UNITED STATES  
DEPARTMENT OF THE INTERIOR  
BUREAU OF LAND MANAGEMENTFORM APPROVED  
OMB NO. 1004-0137  
Expires: January 31, 2018**SUNDRY NOTICES AND REPORTS ON WELLS**  
*Do not use this form for proposals to drill or to re-enter an abandoned well. Use form 3160-3 (APD) for such proposals.***SUBMIT IN TRIPLICATE - Other instructions on page 2**

| 3b. Phone No. (include area code)<br>719.493.005   | 8. Well Name and No.<br>VIRGO 24/23 B2AD FED COM 1H |

Mewbourne Oil Company has an approved APD for the above well. Mewbourne requests approval to make the following changes:

- 1) Change casing and cement design (Change 9 5/8" setting depth).
- 2) Change wellhead to multi-bowl type wellhead.
- 3) Change to flexible choke line.

### 10K CEMENTING ASSEMBLY PRESSURE TEST CERTIFICATE

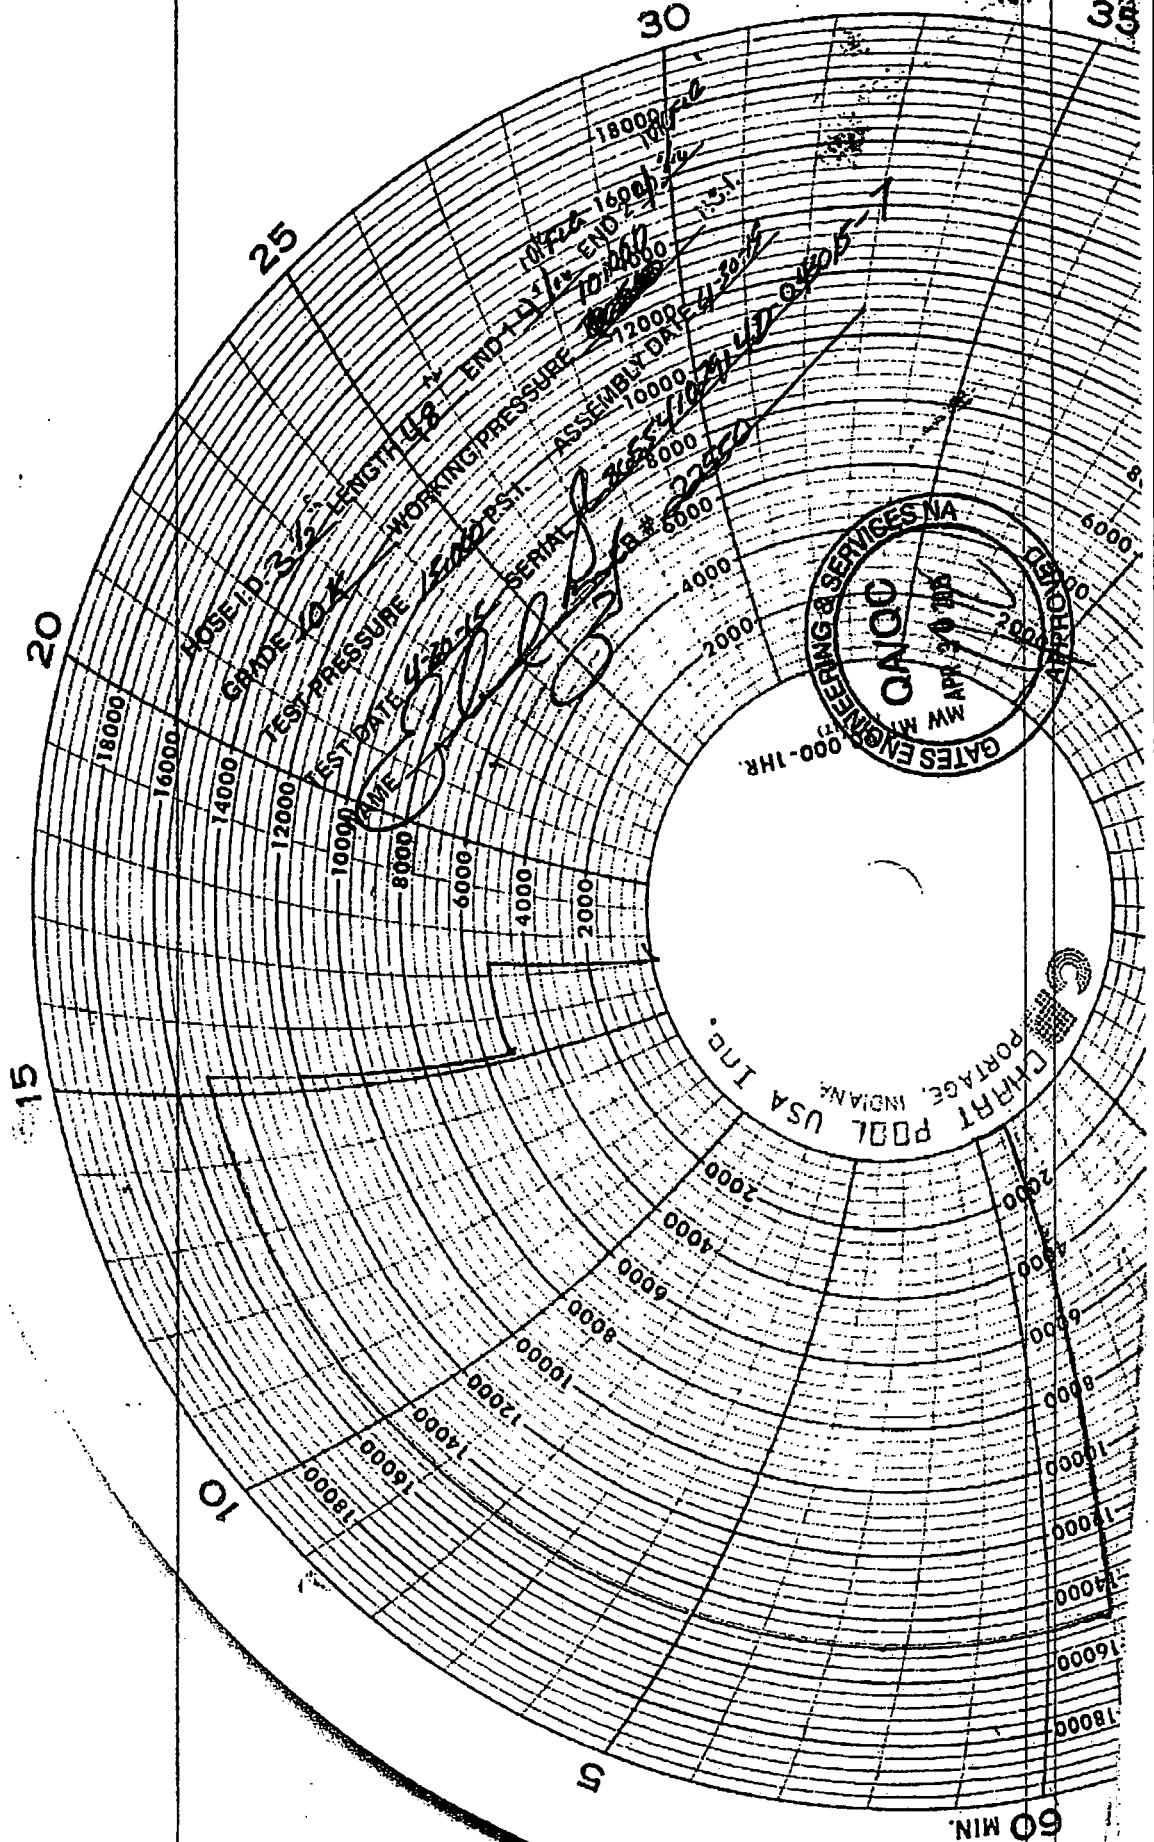
| Y | A variance is requested for the use of a flexible choke line from the BOP to Choke Manifold. See attached for specs and hydrostatic test chart.   |

2. If a variance is approved for a flexible hose to be installed from the BOP to the choke manifold, the following requirements apply: Check condition of flexible line from BOP to choke manifold, replace if exterior is damaged or if line fails test. Line to be as straight as possible with no hard bends and is to be anchored according to Manufacturer's requirements. The flexible hose can be exchanged with a hose of equal size and equal or greater pressure rating. Anchor requirements, specification sheet and hydrostatic pressure test certification matching the hose in service, to be onsite for review. These documents shall be posted in the company man's trailer and on the rig floor.

## 13-5/8" MN-DS Wellhead System

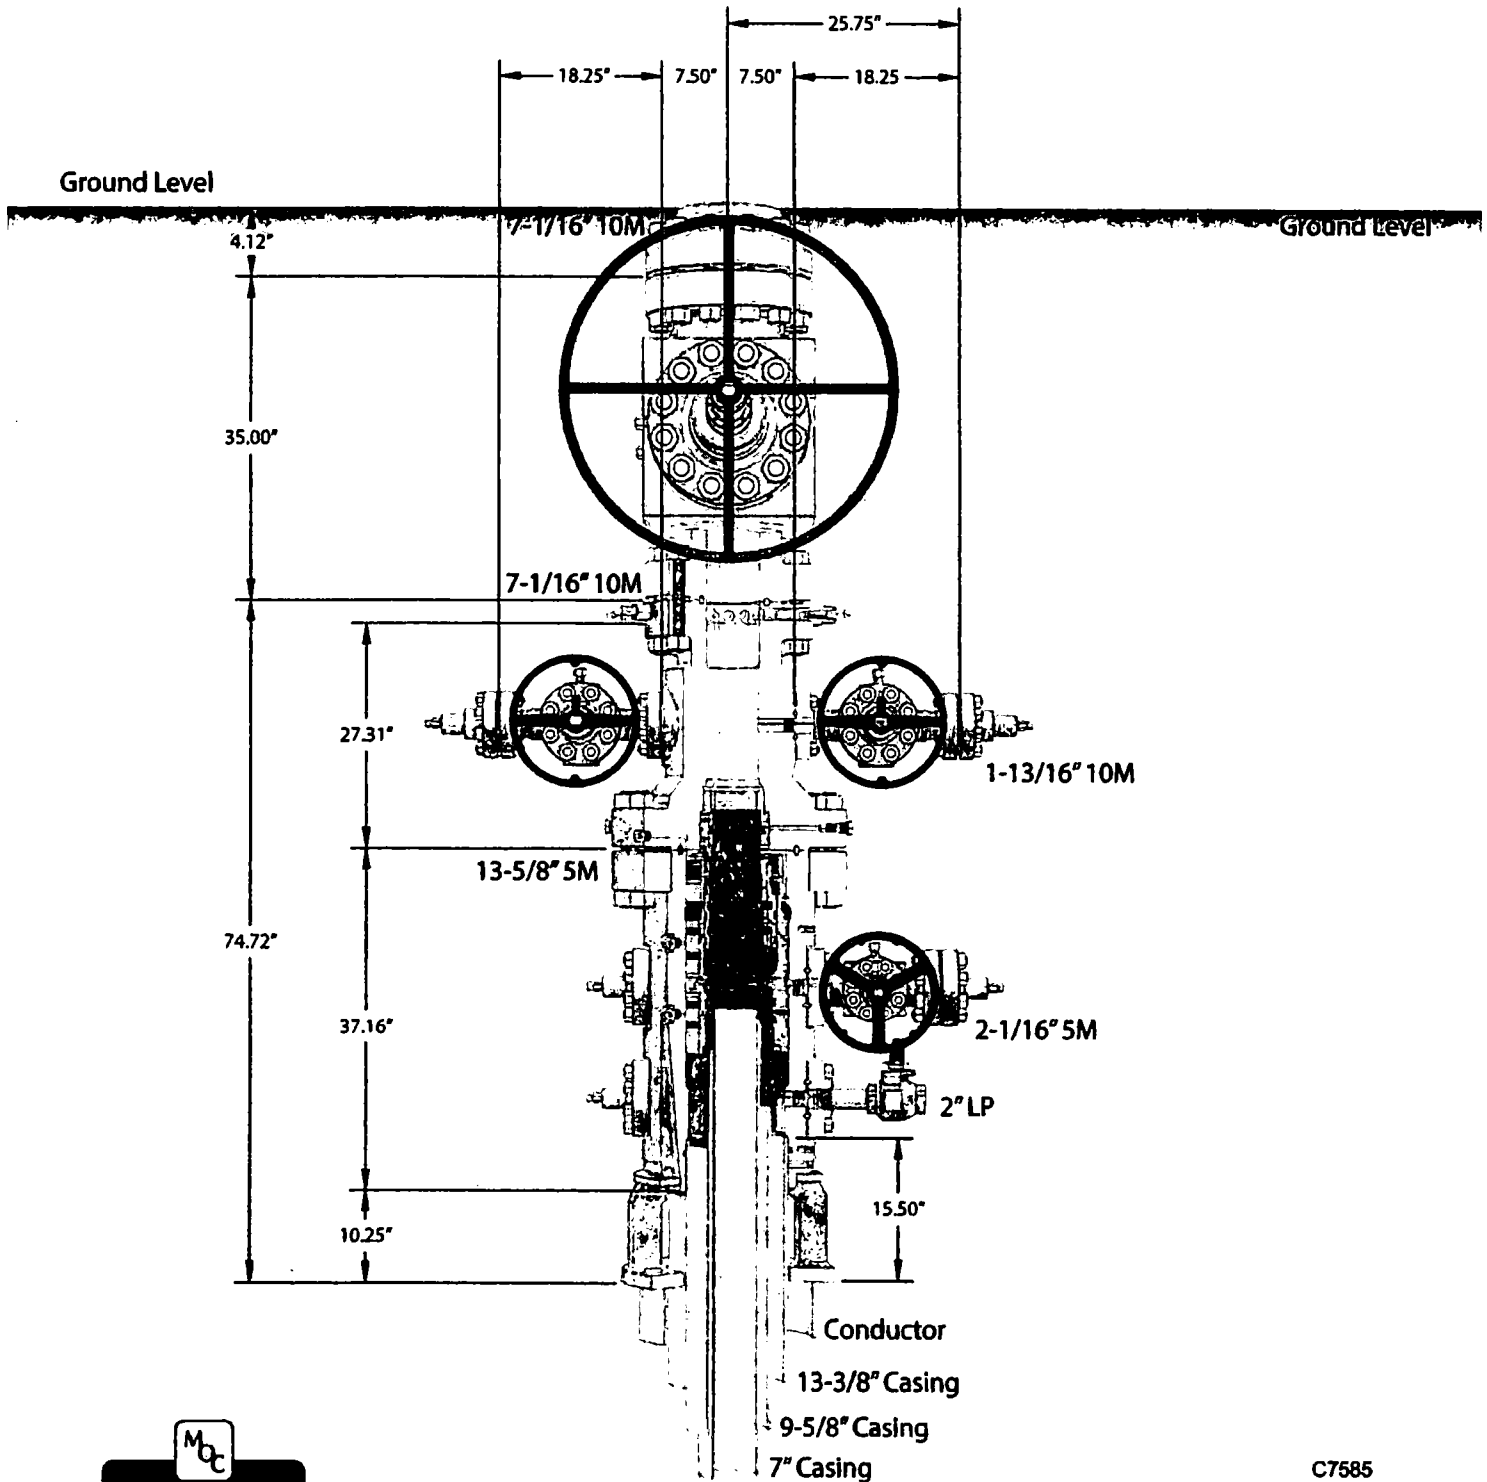
| Y | A multibowl wellhead is being used. The BOP will be tested per Onshore Order #2 after installation on the surface casing which will cover testing requirements for a maximum of 30 days. If any seal subject to test pressure is broken the system must be tested.<br><br>• Provide description here: See attached schematic. |

4. **If the operator has proposed a multi-bowl wellhead assembly in the APD. The following requirements must be met:**
  - a. **Wellhead shall be installed by manufacturer's representatives, submit documentation with subsequent sundry.**

- b. **If the welding is performed by a third party, the manufacturer's representative shall monitor the temperature to verify that it does not exceed the maximum temperature of the seal.**

- c. **Manufacturer representative shall install the test plug for the initial BOP test.**
  - d. **Operator shall perform the intermediate casing integrity test to 70% of the casing burst. This will test the multi-bowl seals.**

- e. **If the cement does not circulate and one inch operations would have been possible with a standard wellhead, the well head shall be cut off, cementing operations performed and another wellhead installed.**
